**Drain:** SADDLE CREEK DRAIN **Drain #:** 295  
**Improvement/Arm:** SADDLE CREEK-SECTION 6  
**Operator:** SLM/JDM **Date:** 6-21-04  
**Drain Classification:** Urban/Rural **Year Installed:** 1998

RE: Saddle Creek Drain, Section 6 Arm

Re: Saddle Creek Drain: Sec. 6 Arm

SADDLE CREEK SEC. 6

DWG. TYPE	FILE NUMBER	SHEET:
		<b>C702</b>
JOB NUMBER		
960324-2000

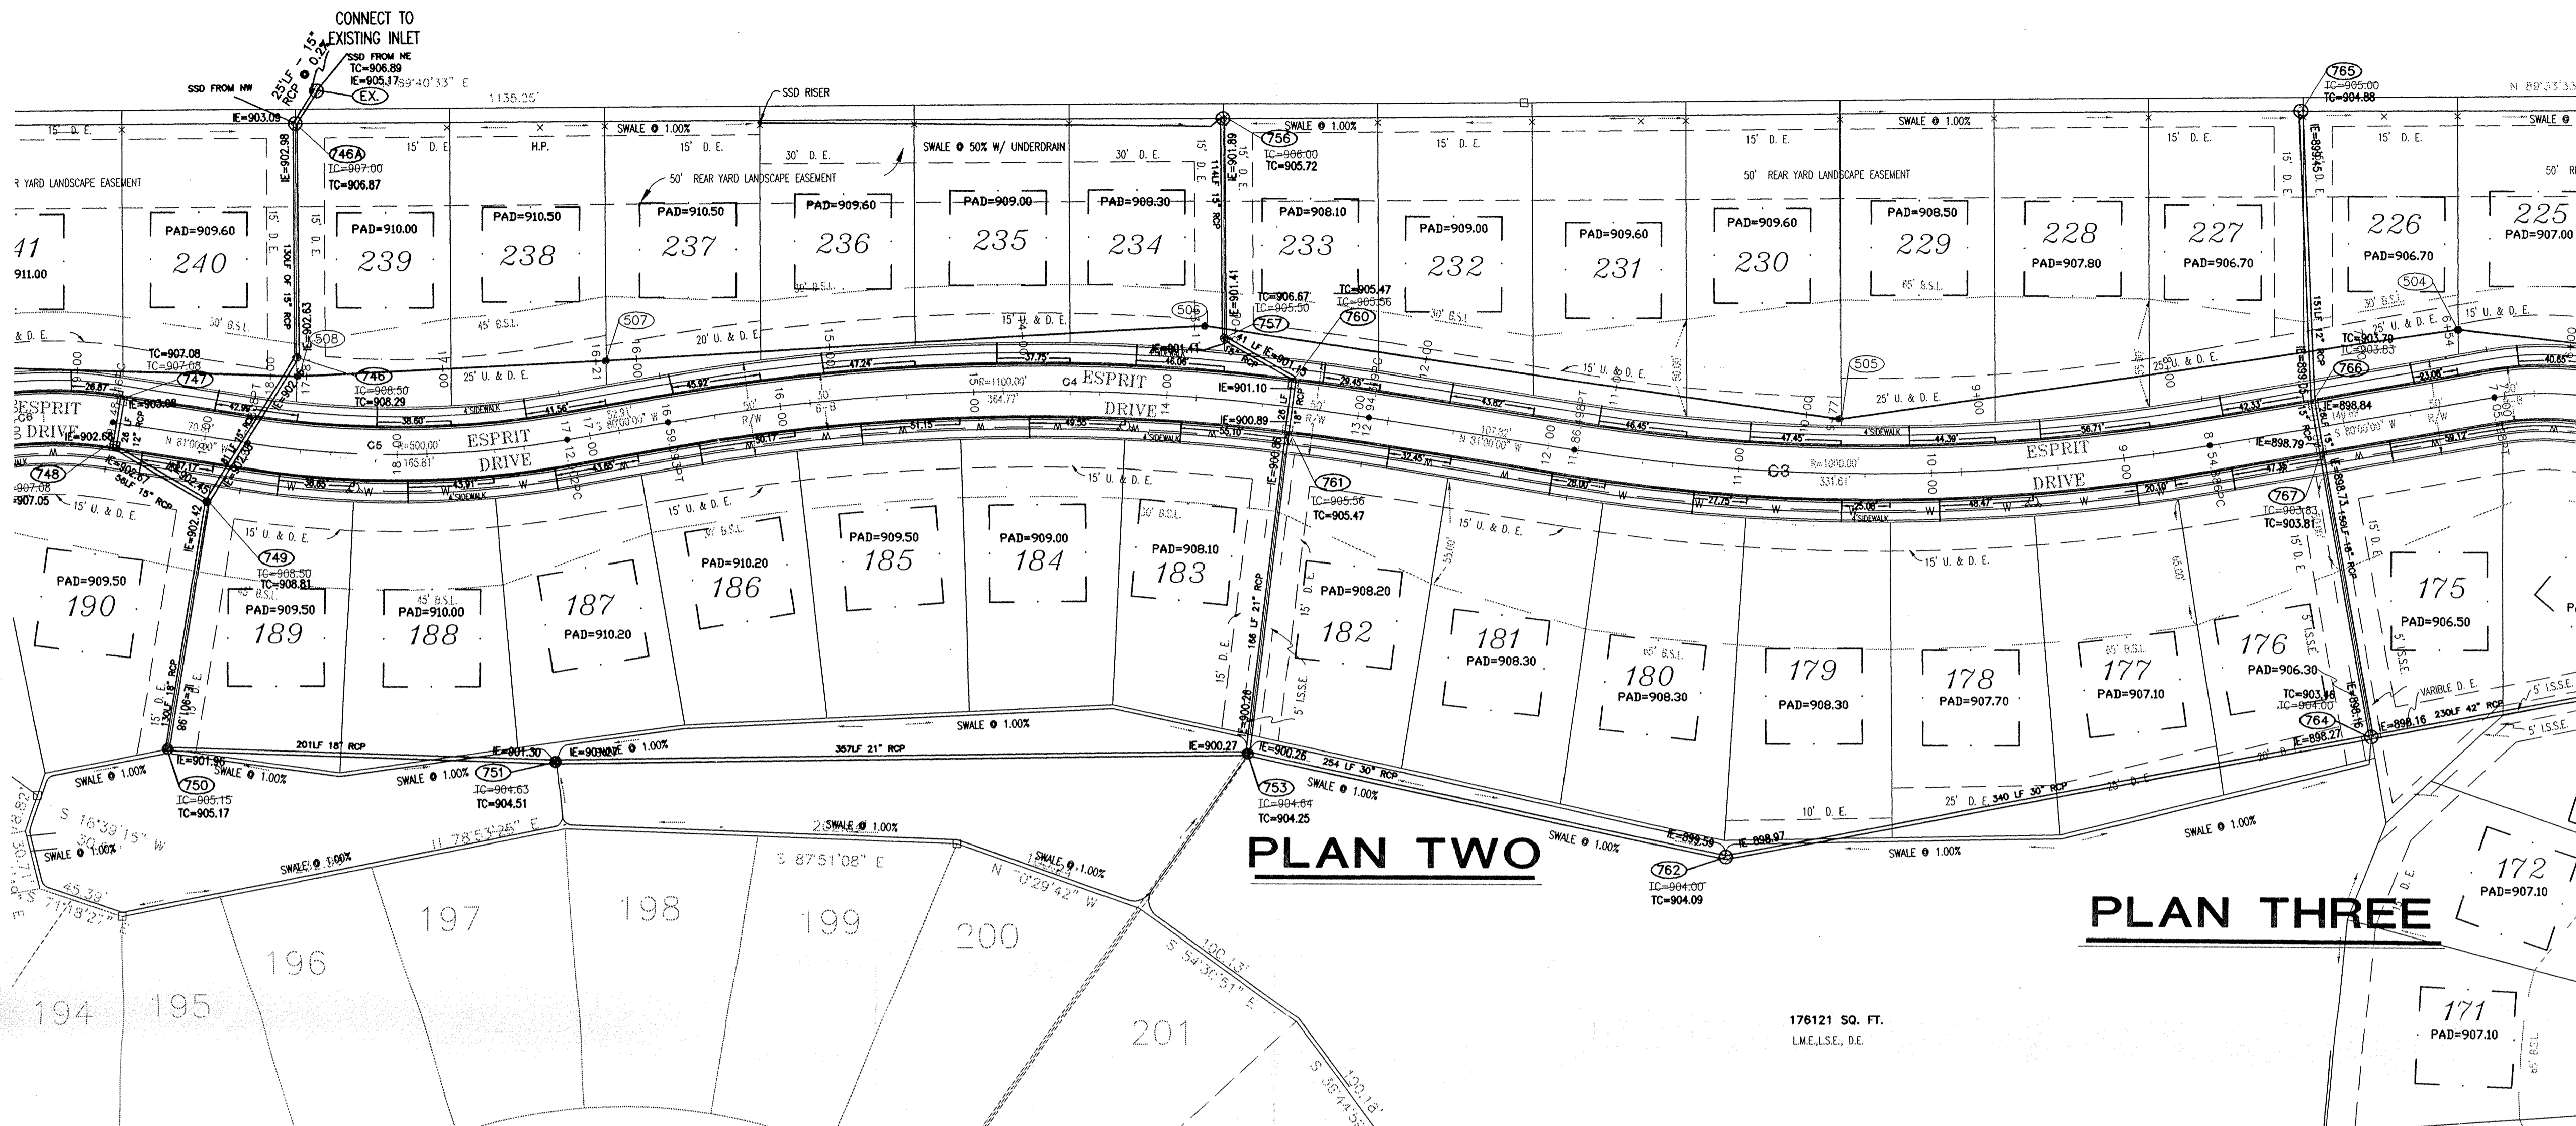
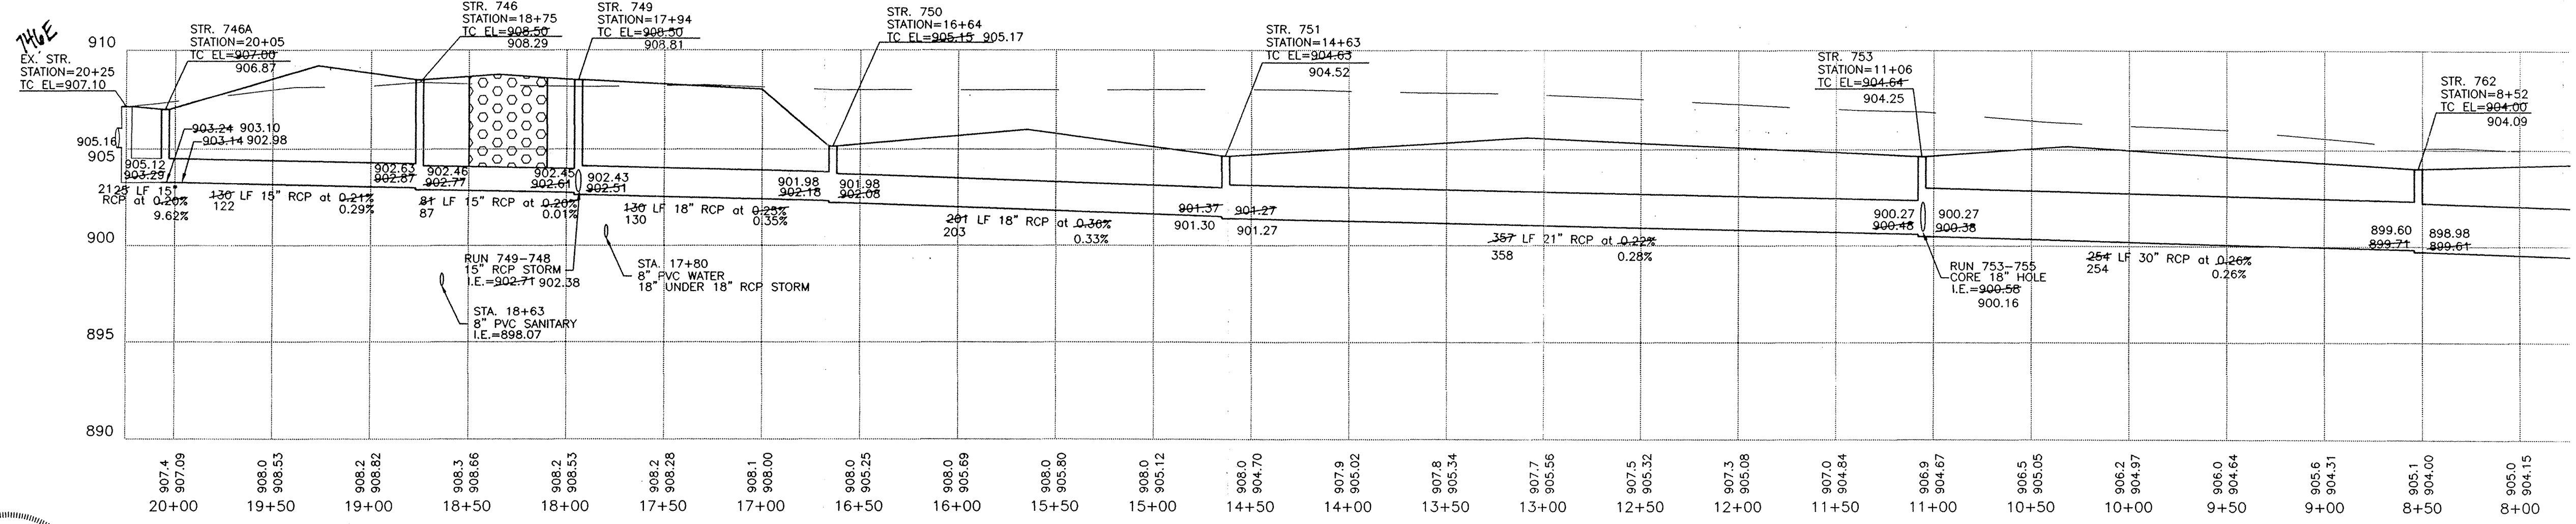
CERTIFIED BY:	REVISIONS		REVISIONS	
	6/8/98 REVISED TOP OF CASTINGS	EFG	12/16/98 REMOVAL OF AUTUMN WOODS DRIVE	MAV
	6/23/98 H. C. SURV. OFFICE REVISIONS	EFG	8/20/99 STORM SEWER AS-BUILTS	MAV
	8/27/98 REVISED STORM RUN 753-756	EFG		
DATE:	9/9/98	REV PER	HCHD

DWG. TYPE	FILE NUMBER	SHEET:
		<b>C703</b>
JOB NUMBER		
960324-20000

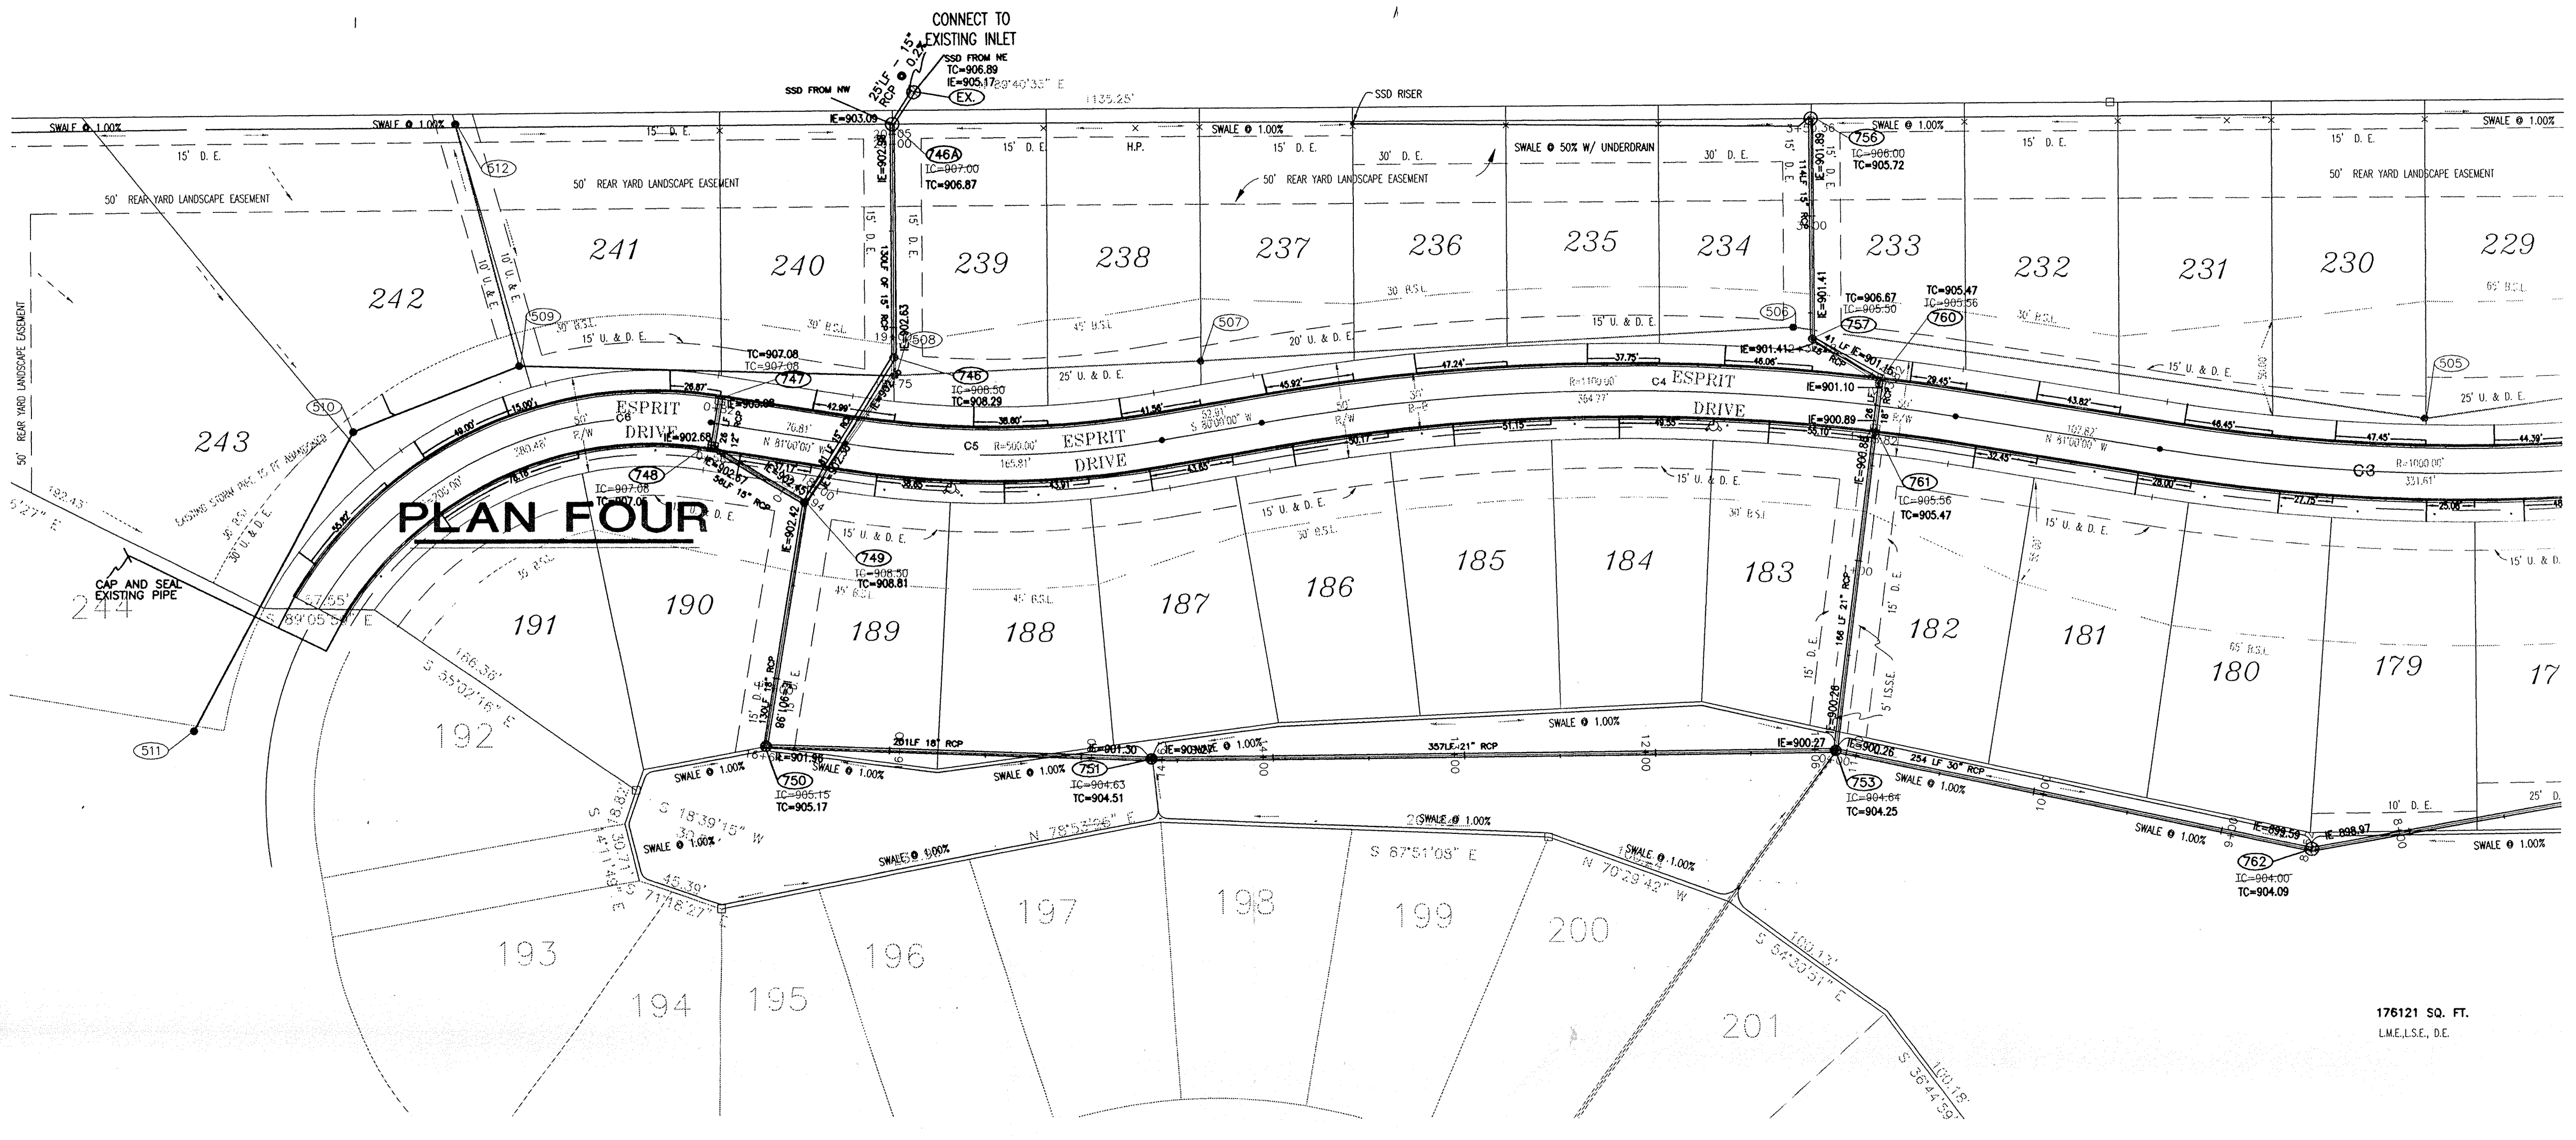
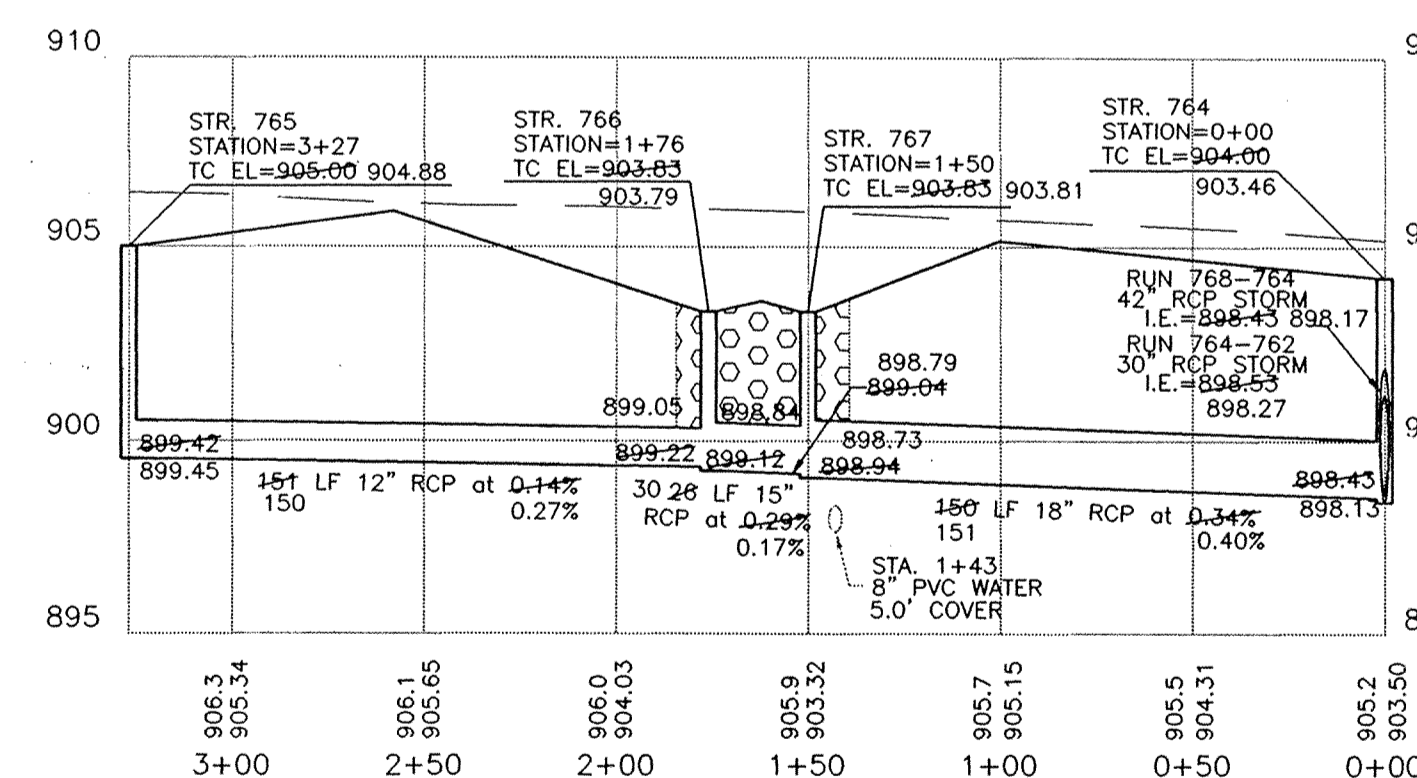
CERTIFIED BY:	REVISIONS	REVISIONS
	6/8/98 REVISED TOP OF CASTINGS EFG	08/20/99 STORM SEWER AS-BUILTS MAV
DATE:	6/23/98 H.C. SURV. OFFICE REVISIONS EFG	
	8/26/98 REV. PROFILE 2 ELIMINATE STR #758 BEH	
	9/8/98 REV. PER HCHD
